Project Advisory Committee (PAC) - Meeting #1 Meeting Summary

On March 20, 2017 the City of Hillsboro Parks & Recreation Project Team met with the Project Advisory Committee (PAC) for the Crescent Park Greenway Trail Plan. The PAC was selected to provide perspective and expertise from a broad range of stakeholders, community advisory boards and professional staff. Members were either appointed by their respective agency or through a formal request at board meetings.

PAC Meeting # 1 Summary

Gordon Faber Recreation Complex Area 1 - Trail Alignments

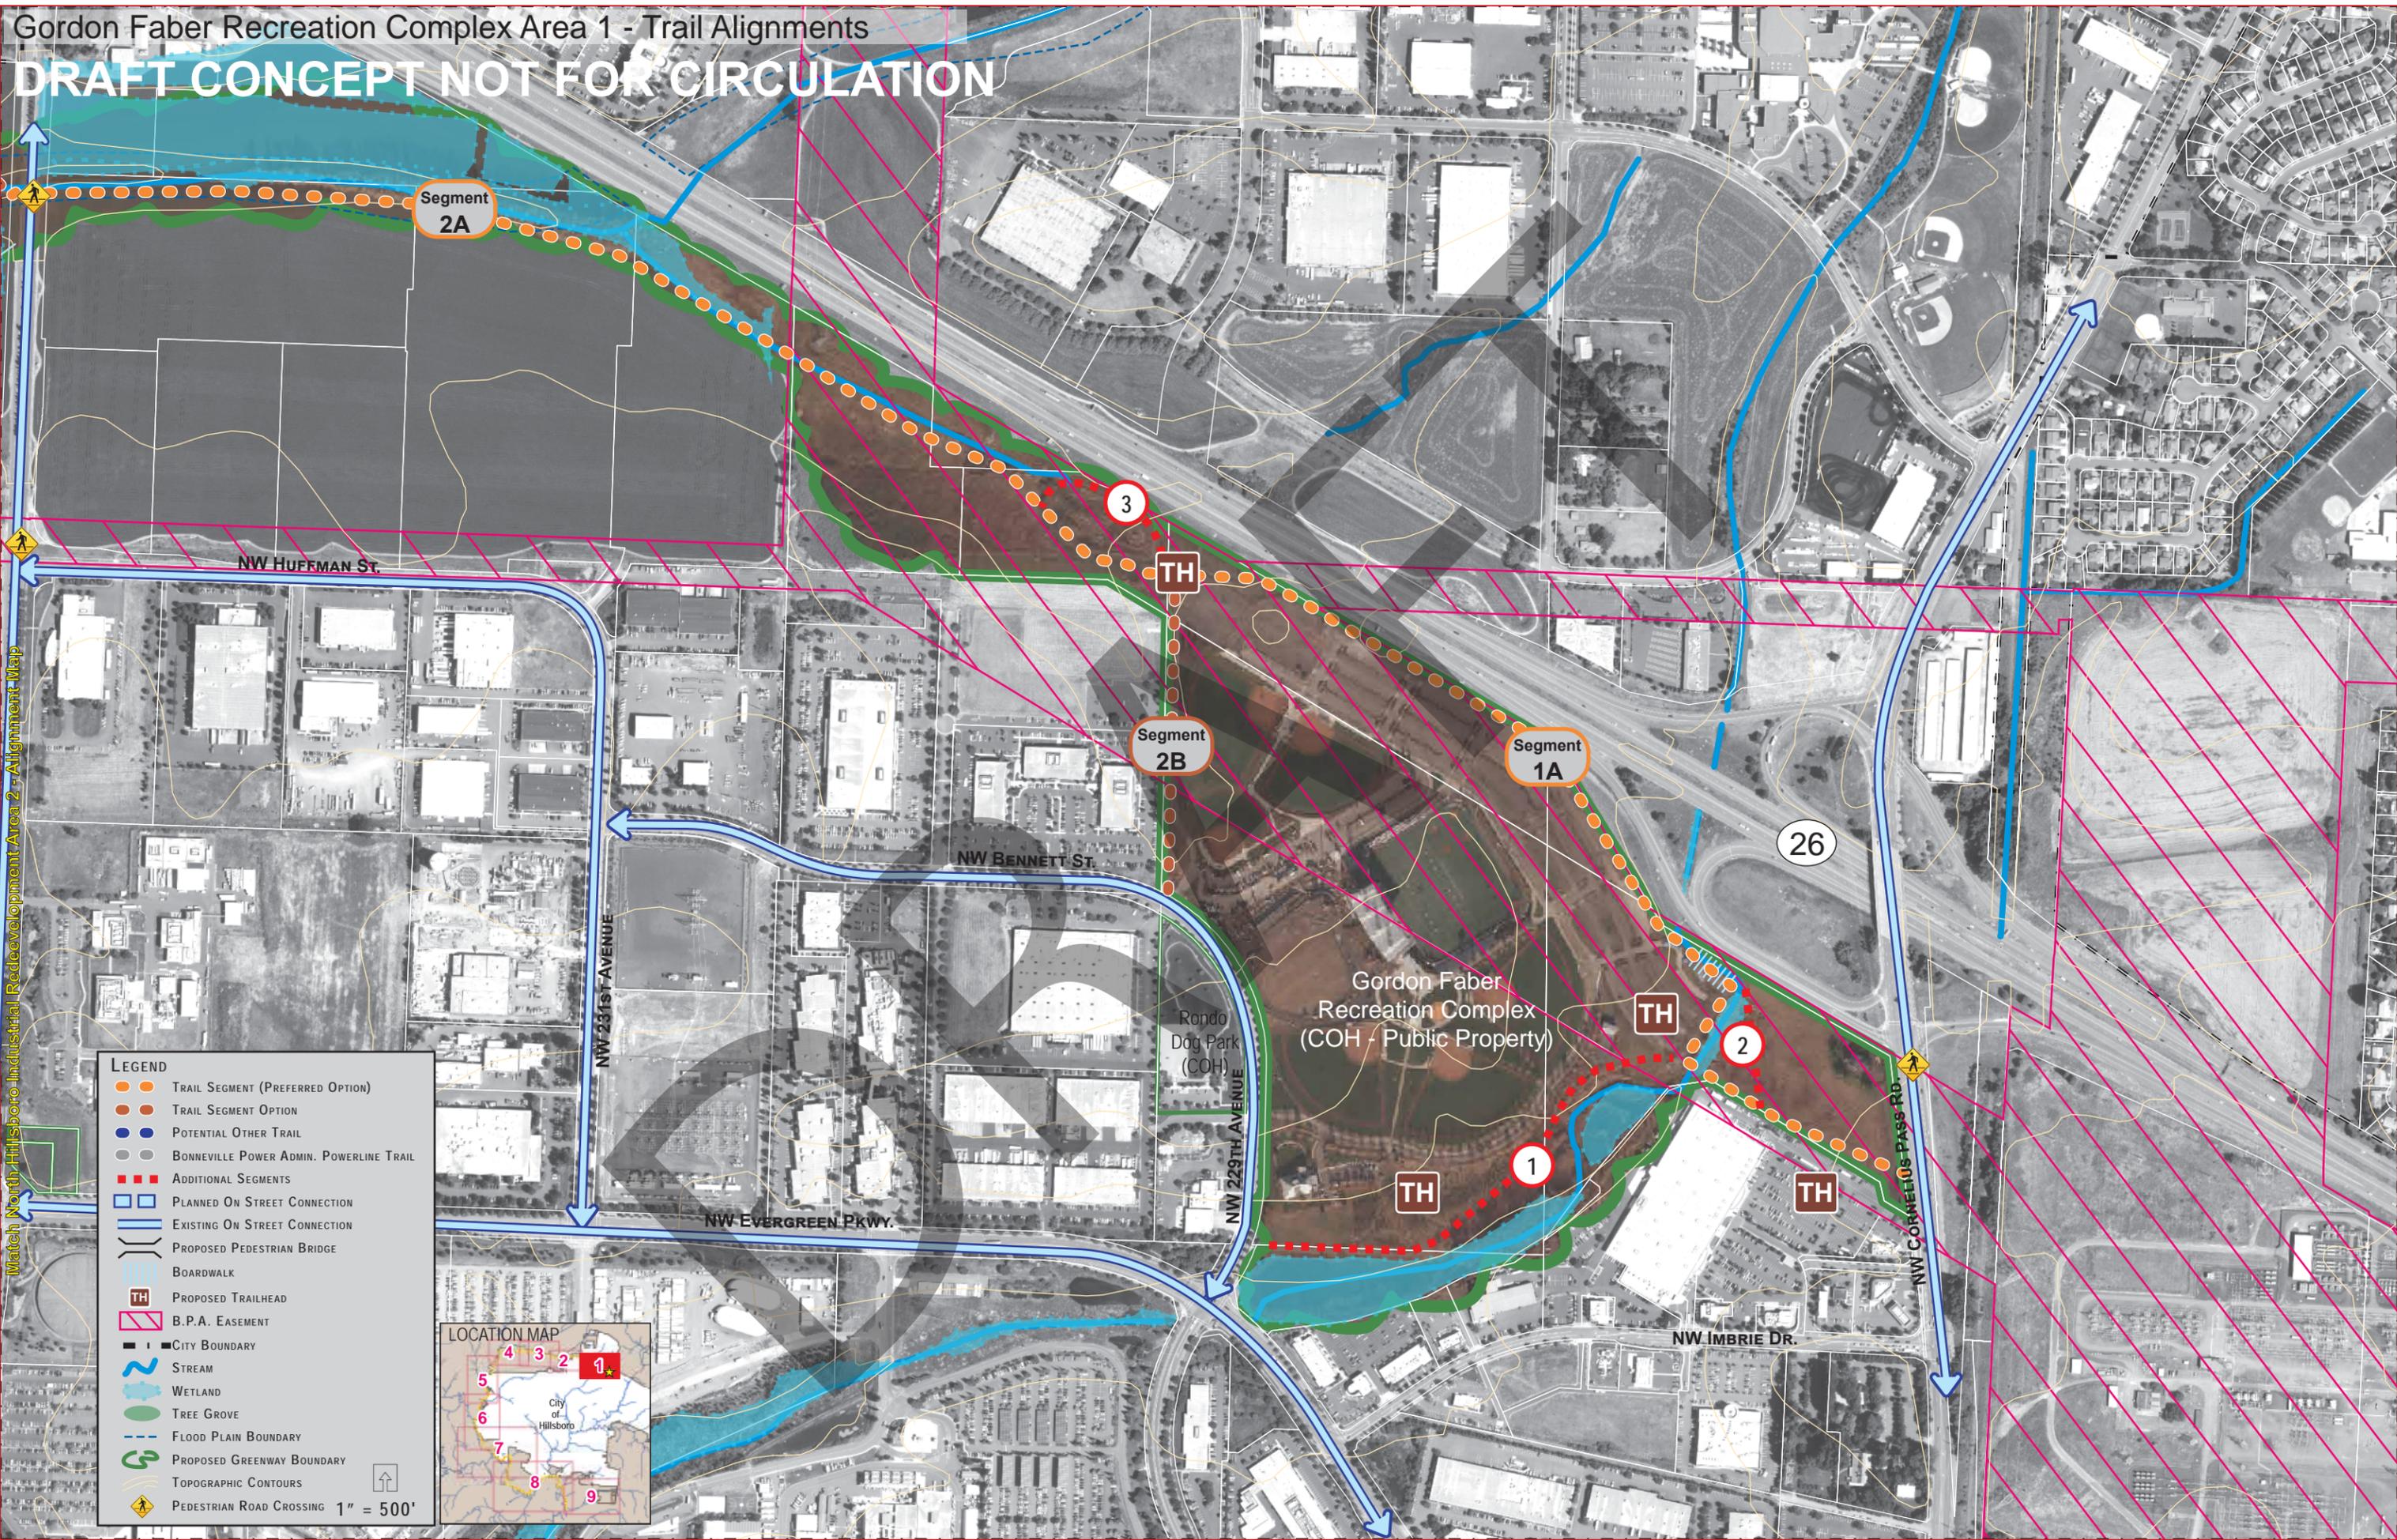
- Add future 229th Ave./Century Blvd. connection over US26. Adjust trail alignments to match.
- Show future Red Electric Regional trail connection line and interface with CPG.
- In narrative, detail how shared facilities could work with private property owners (Fred Meyer).
- Adjust trail alignment over ODOT property, move onto City of Hillsboro property.
- Remove or adjust trailhead that is in the 229th Ave./Century Blvd. alignment by US26.
- Segments 1A and 2A may be paved, articulate in narrative.
- Work with other PAC members to determine the CPG crossing over Brookwood Parkway that is safe and does not negatively affect the trail user experience. Add potential overpass to Brookwood Parkway.

North Hillsboro Industrial Redevelopment Area 2 - Trail Alignments

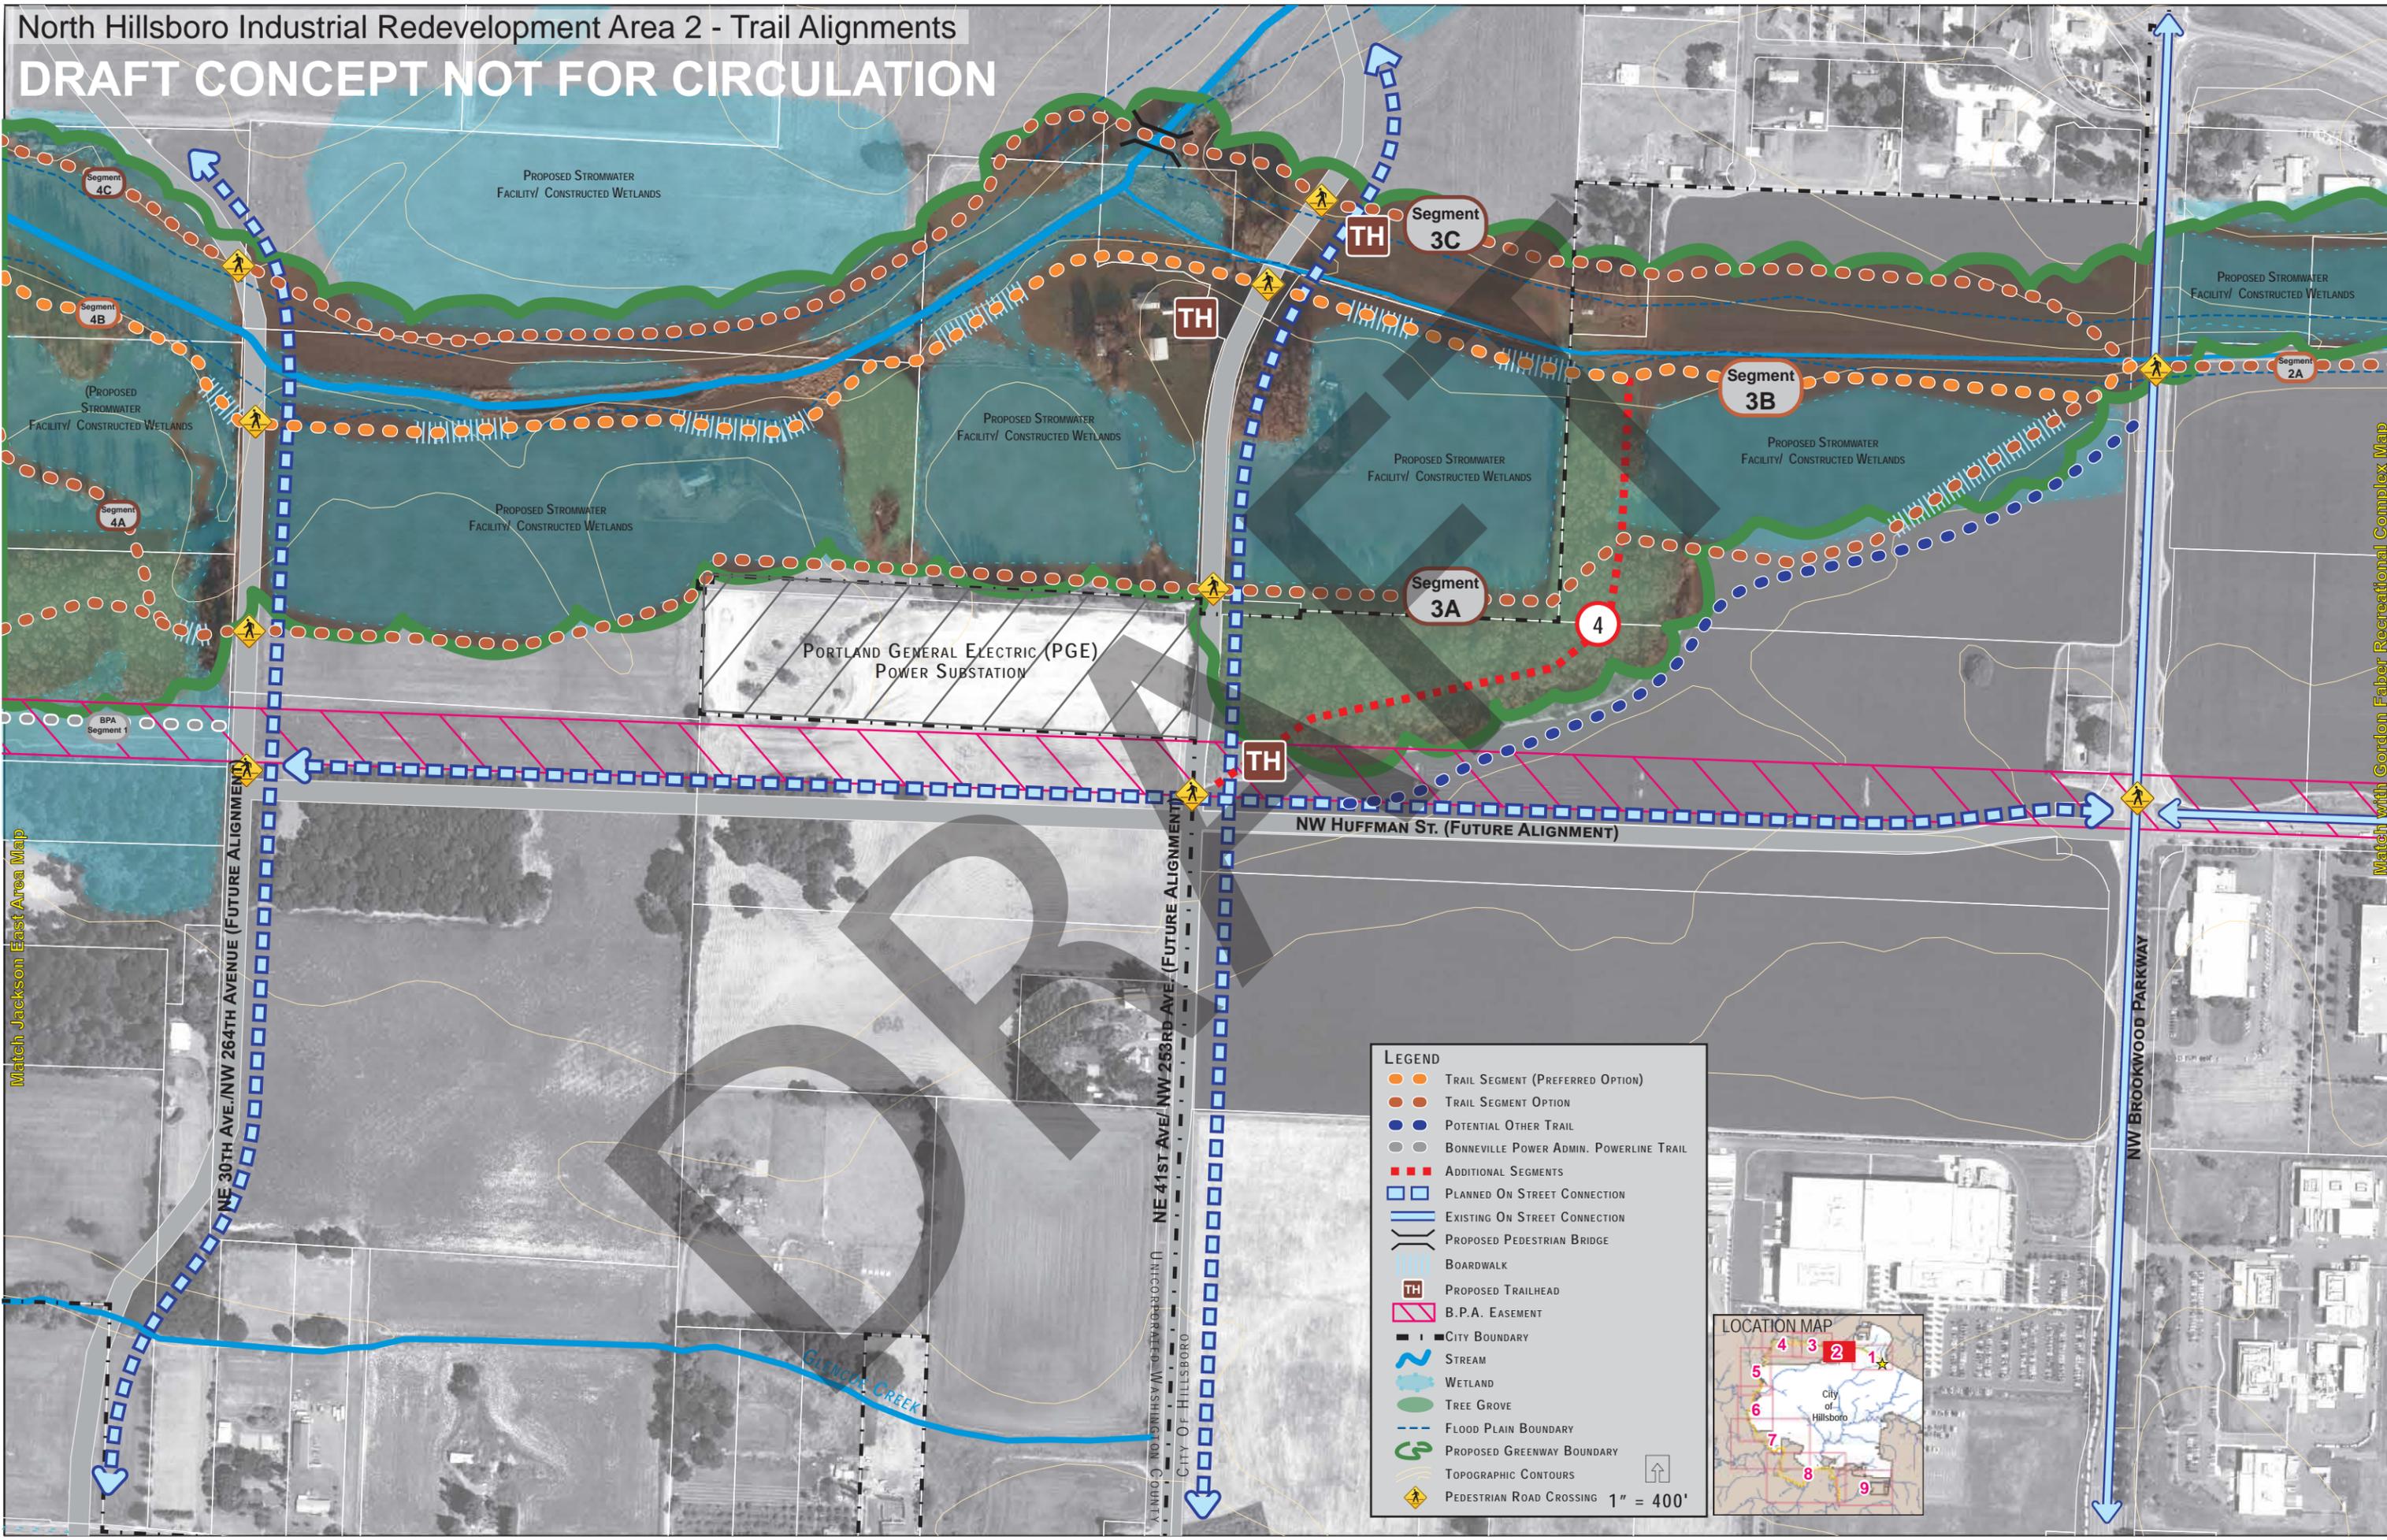
- Adjust maps to new proposed configurations of stormwater facilities, road alignments and protected resources.
- Extend BPA trail alignment along Huffman to Brookwood Parkway.
